ADDENDUM 2

TO: All Prospective Bidders
PROJECT NO: 16822000
PROJECT NAME: Iowa Workforce Development – 2nd & 3rd Floor Remodel
CLIENT NAME: State of Iowa / DAS
PROJECT LOCATION: Des Moines, IA
DATE: 5/12/2017
CONTACT: Joe Wallace, AIA

SA100

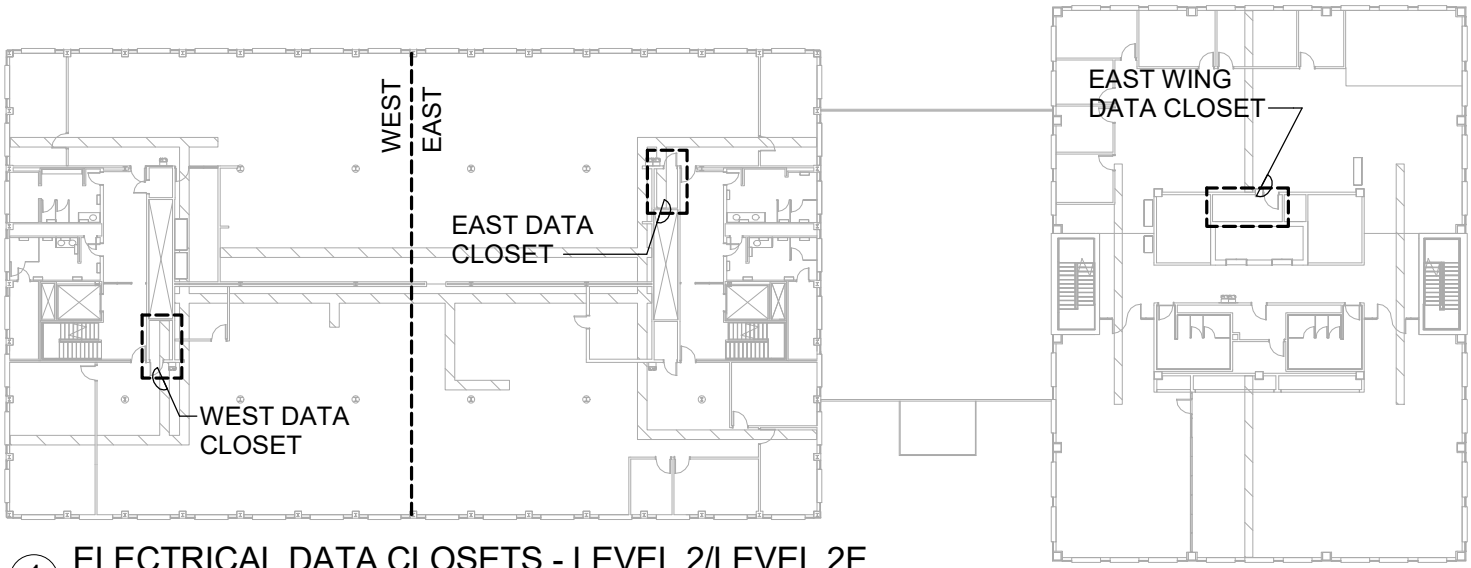
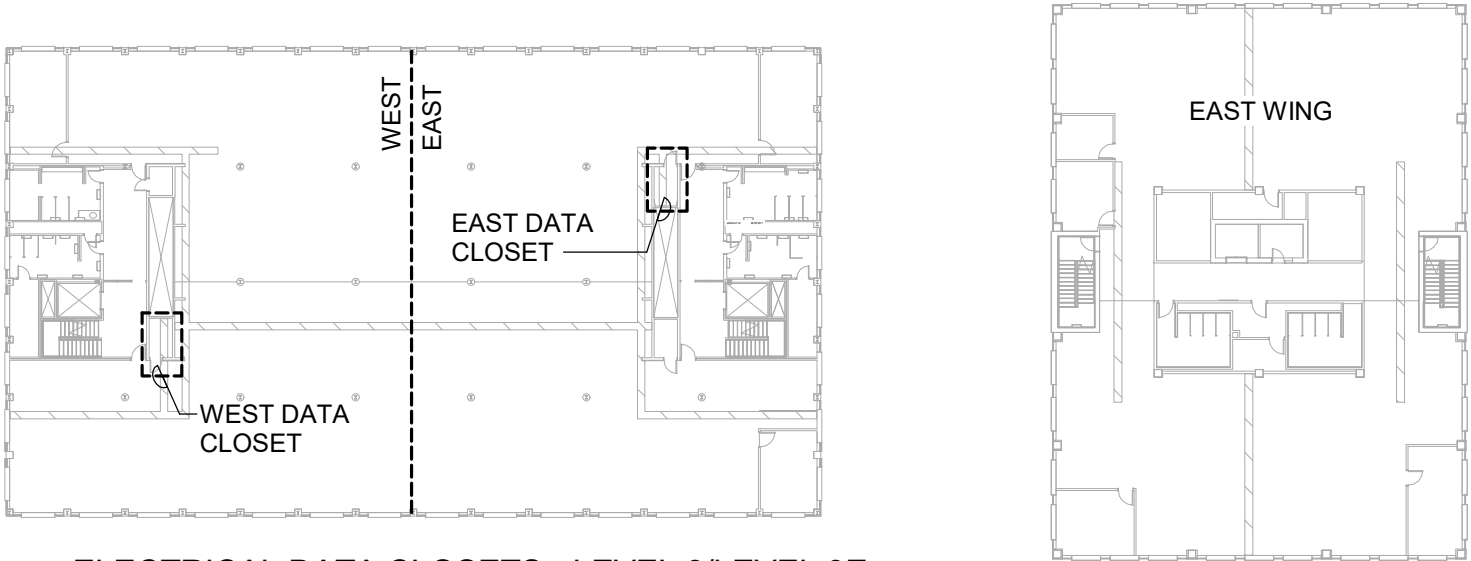
- d. Add Paragraph 7.6 in its entirety, ***"This contractor shall be responsible for the installation of VCT per detail SA100 added in Addendum #02 to bring abated area around new activations level with the existing VCT prior to carpet install."***

- c. See attached supplemental detail SA100 indicating flooring intent at new activations. Coordinate locations with electrical drawings.
- d. Revise PCT – 1 to read:

SE001

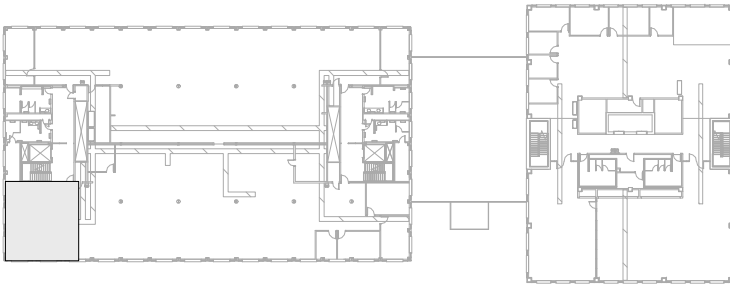
4.14 SHEET E001 – ELECTRICAL DATAT CLOSET LOCATIONS

- a. Reference attached supplemental drawing SE001.

SED102W

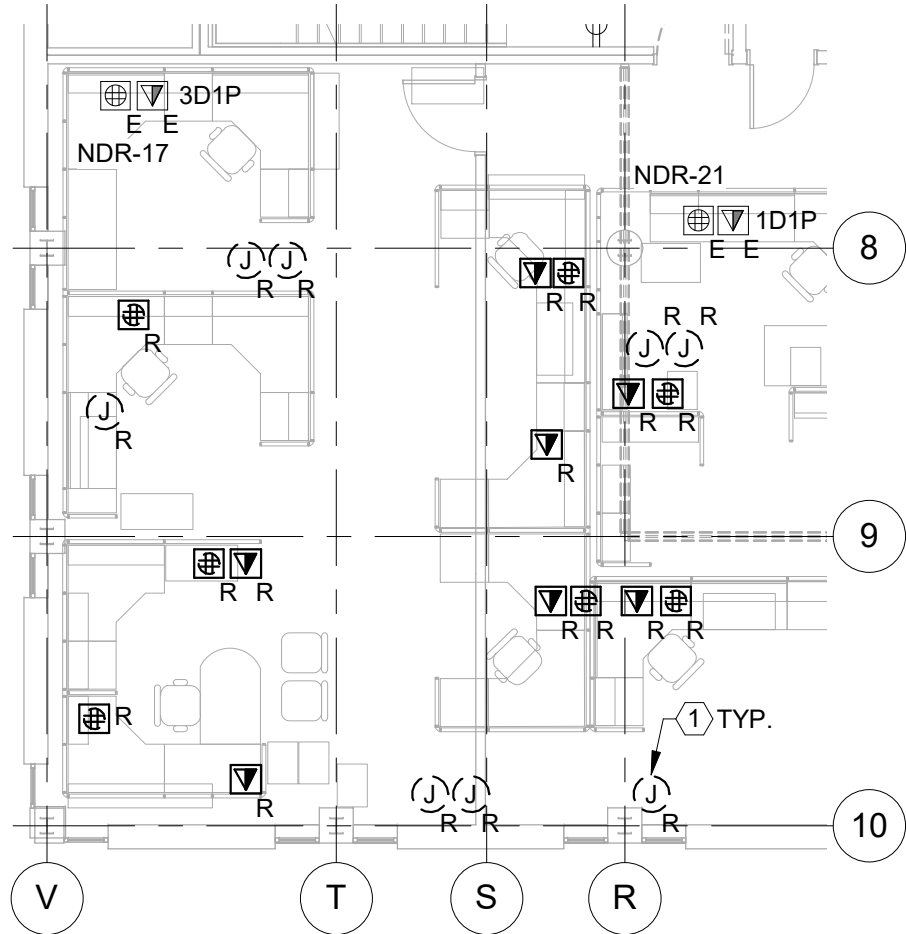
4.15 SHEET ED102W - DEMO FLOOR LEVEL 2 - WEST

- b. Reference attached supplemental drawing SED102W.

SE102W

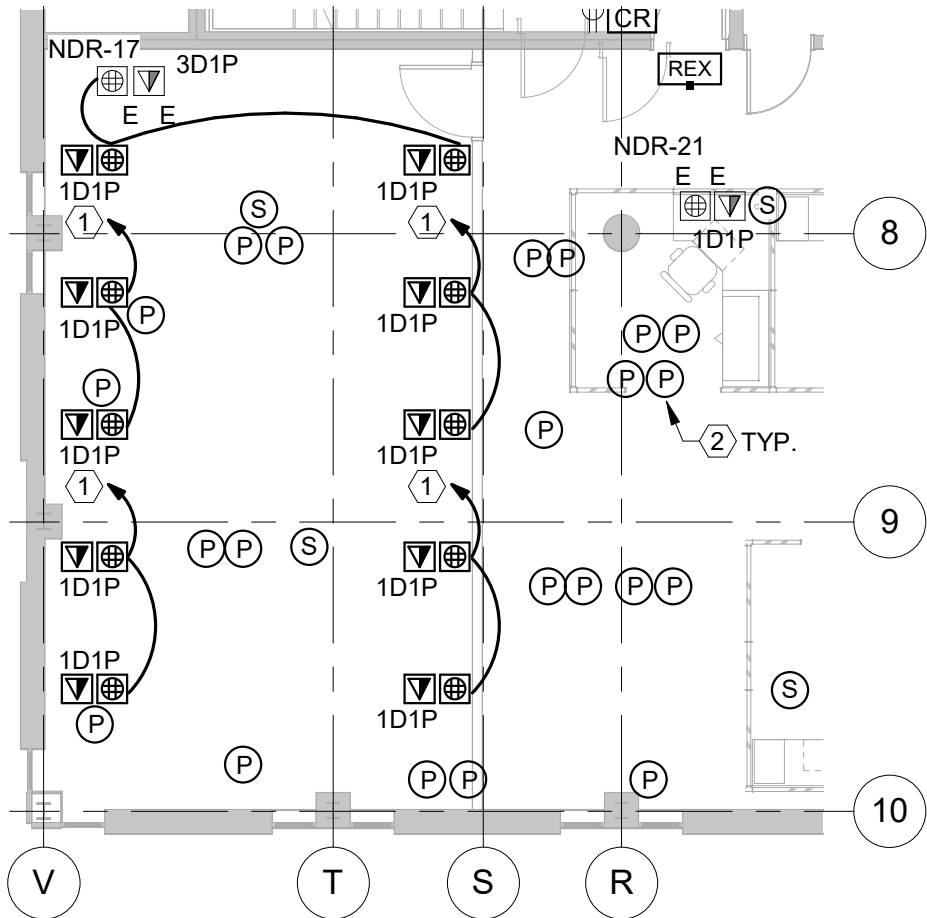
2. SHEET E102W – POWER AND FLOOR SYSTEMS LEVEL 2 - WEST

- c. Reference attached supplemental drawing SE102W.

A102E

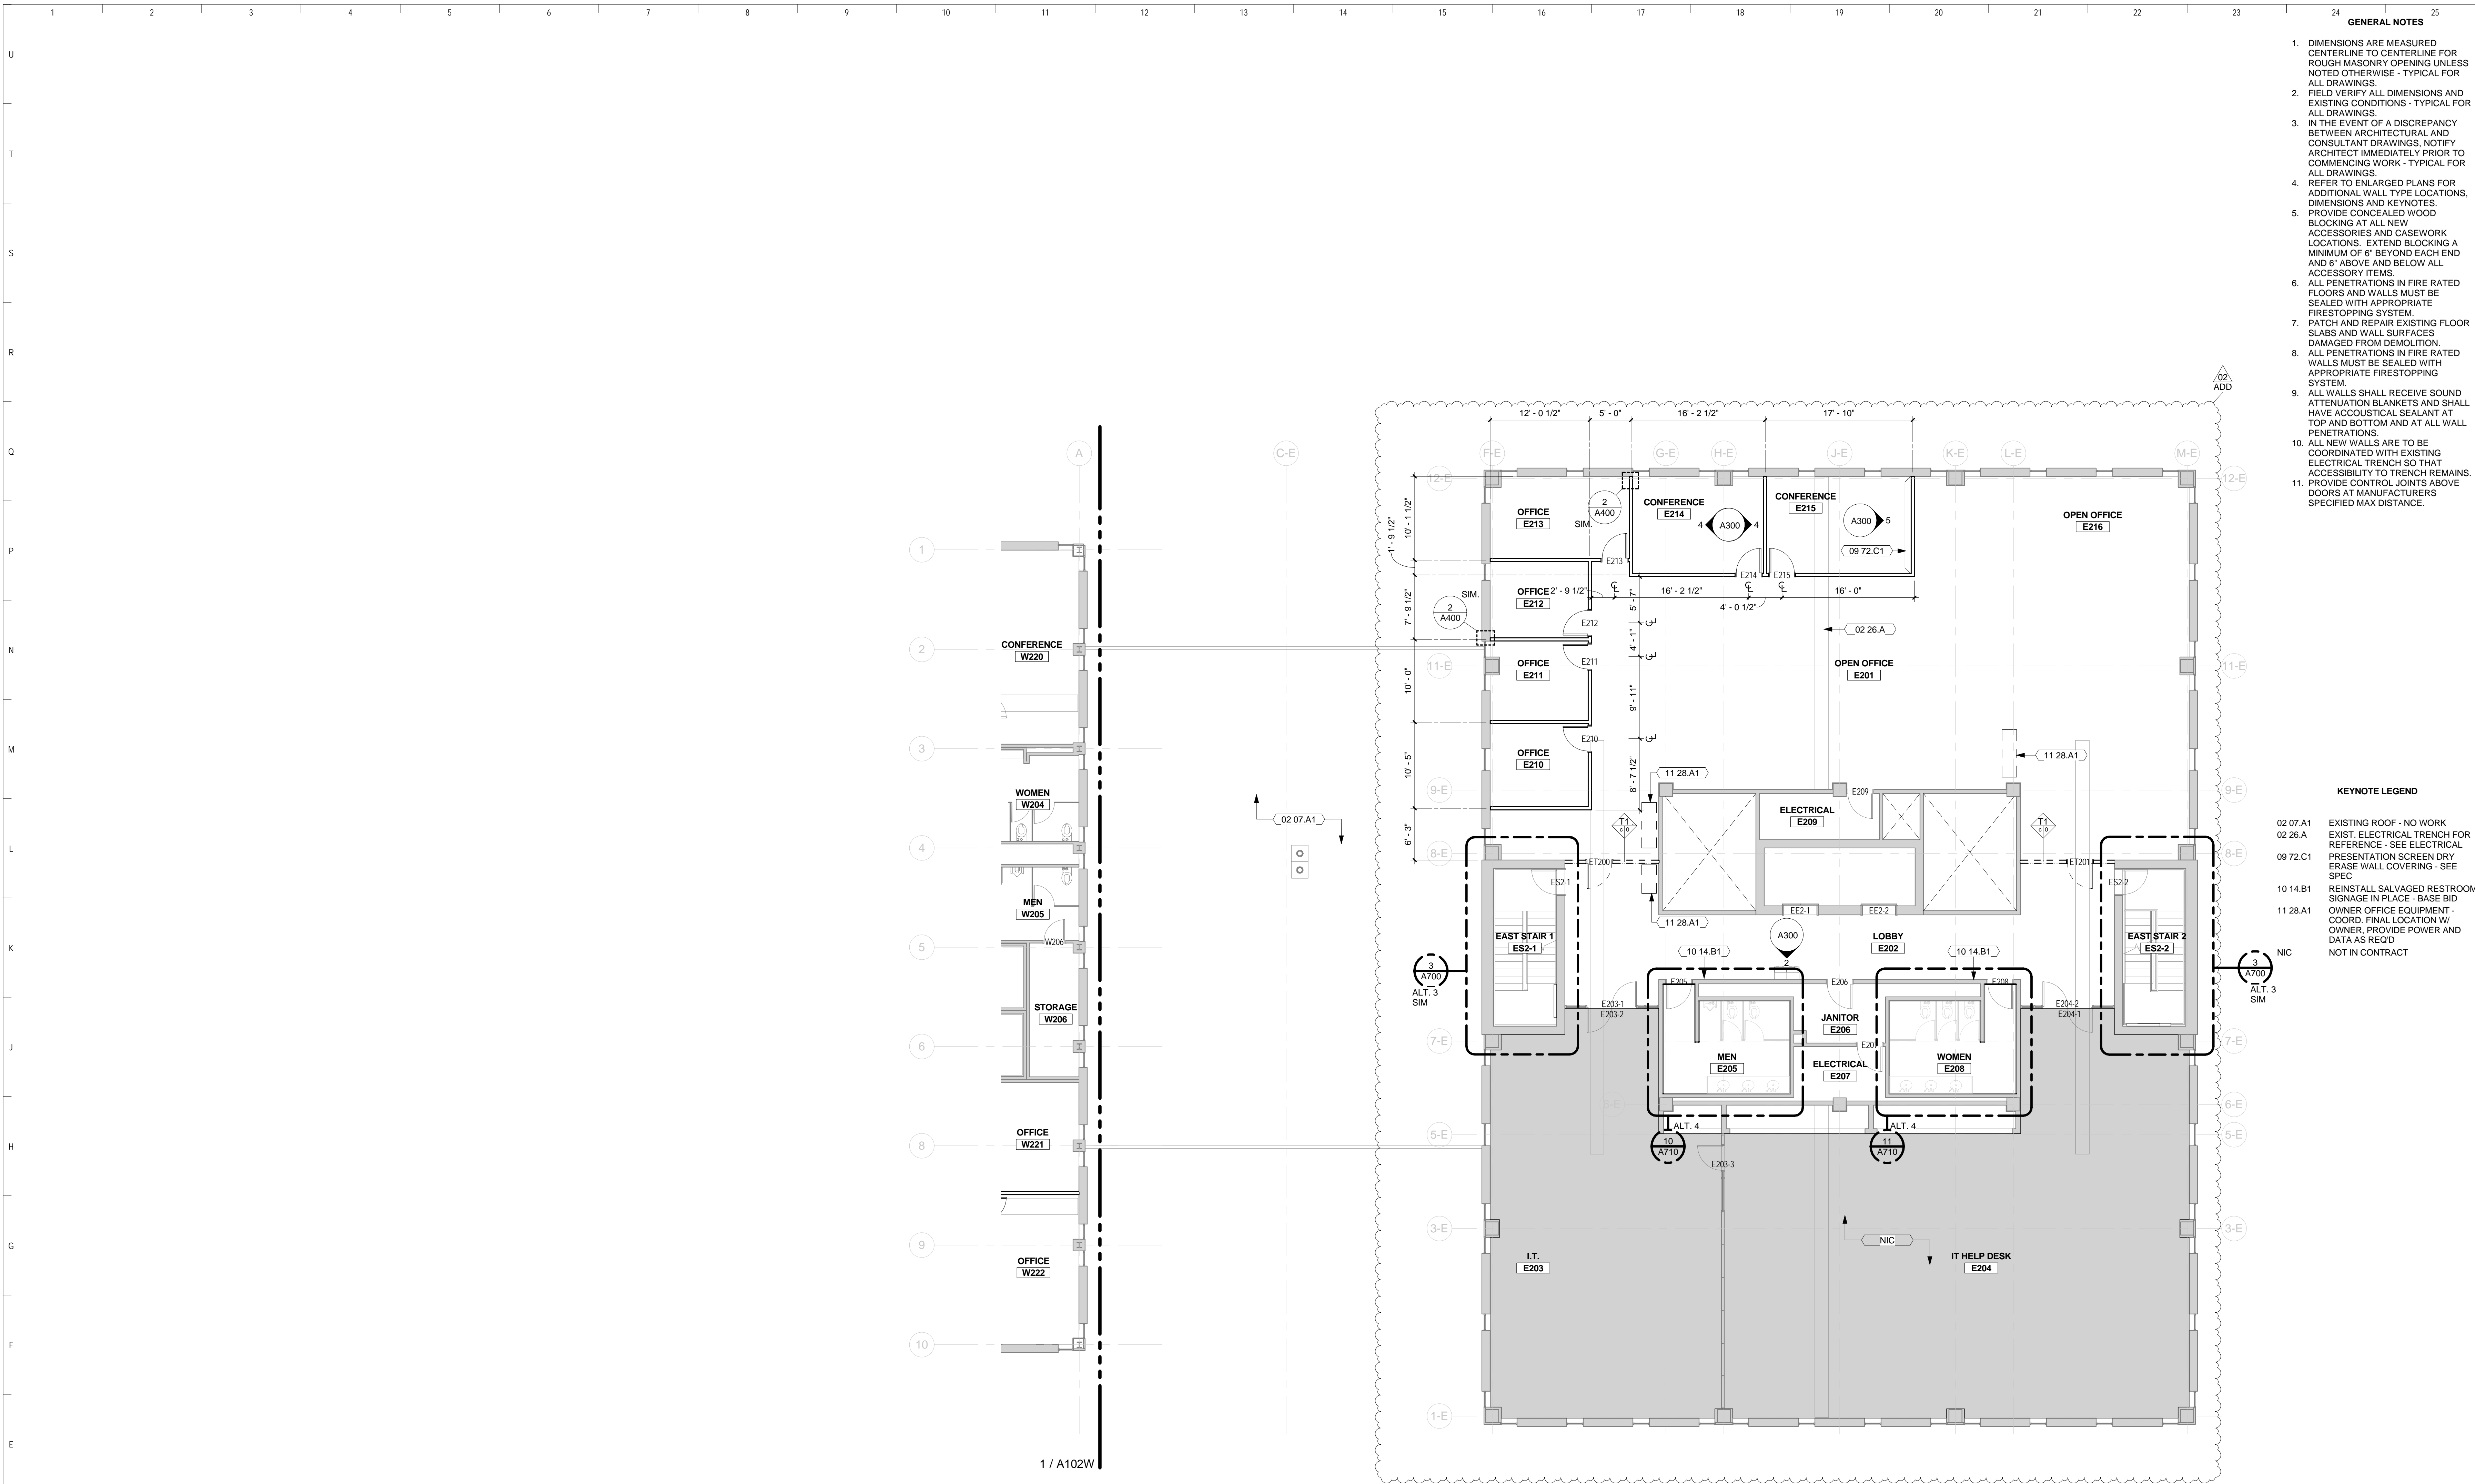
4.5 A102E – ALT. 1 – FLOOR PLAN LEVEL 2 - EAST

- a. Revise Sheet as shown to remove Room E216. Remove walls and Door E216 from the project.
b. Revise Room E217 to read, “E216”
c. Revise dimensioning at Room E215 to read, “16'-0”.

1 ALT. 1 - LEVEL 2 FINISH PLAN - EAST
1/8" = 1'-0"

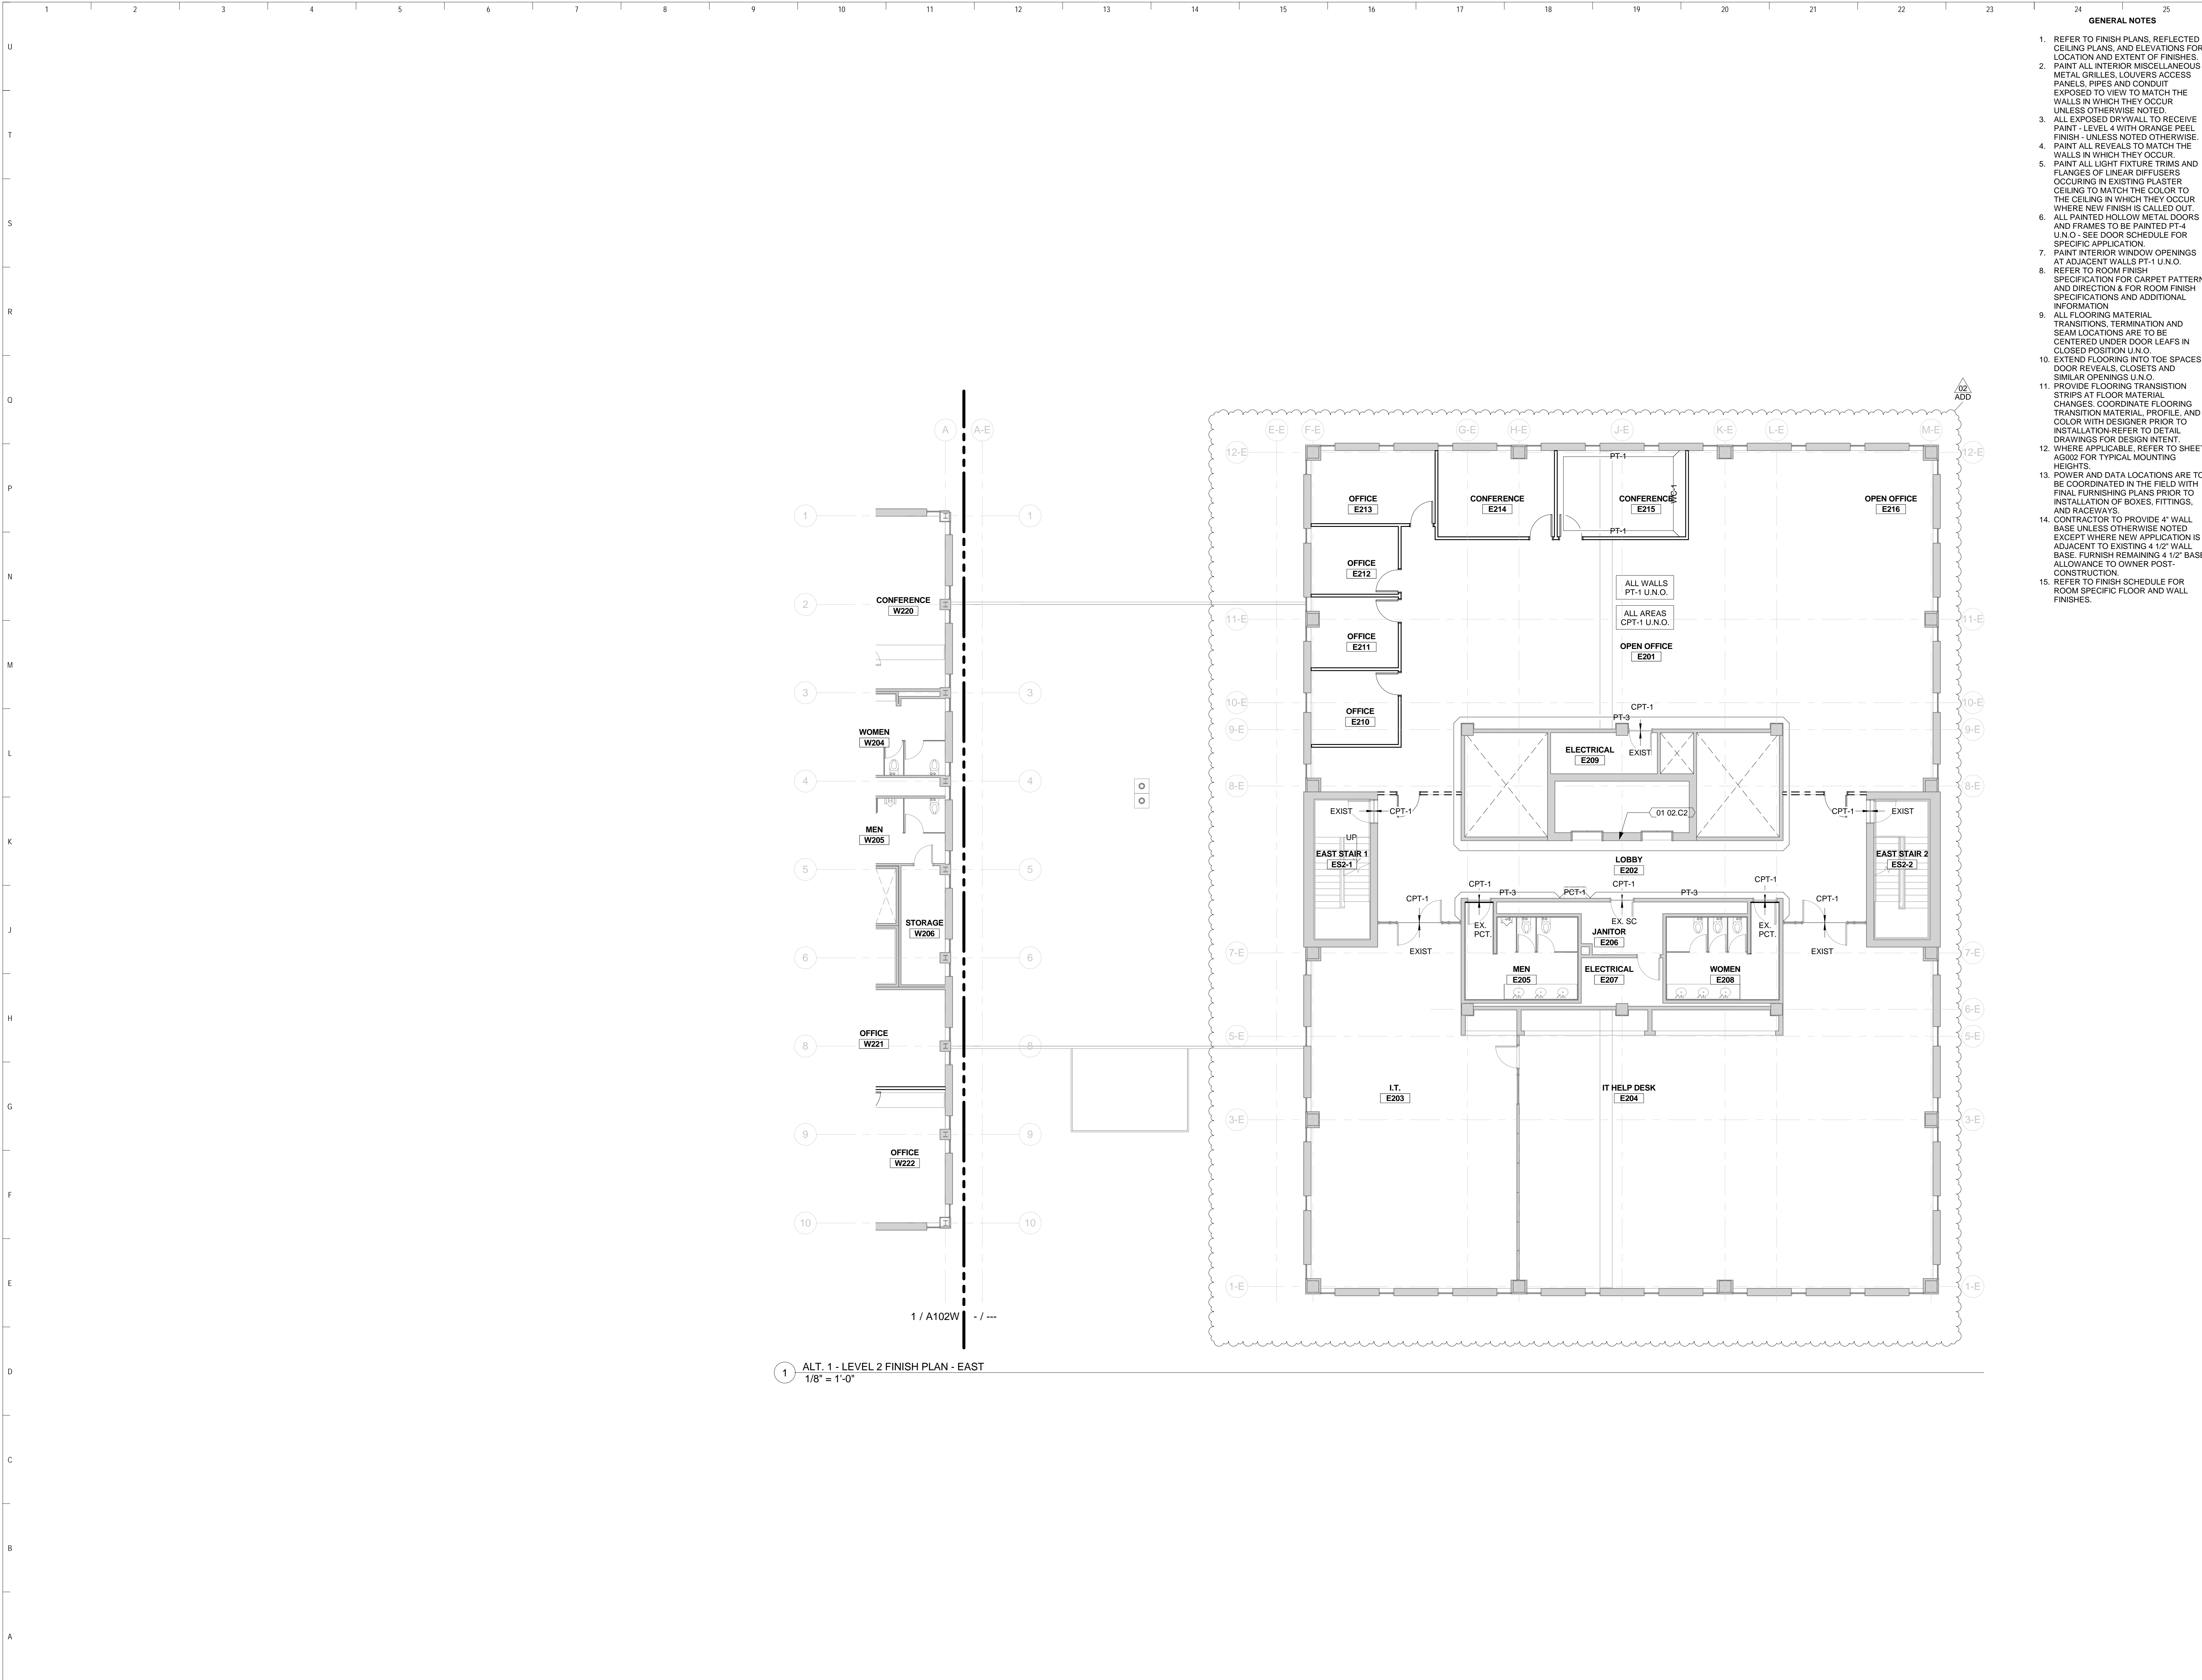
4.9 A512E – FINISH PLAN LEVEL 2 - EAST

- a. Revise Sheet as shown to remove Room E216 and revise Room E217 to read, "E216".
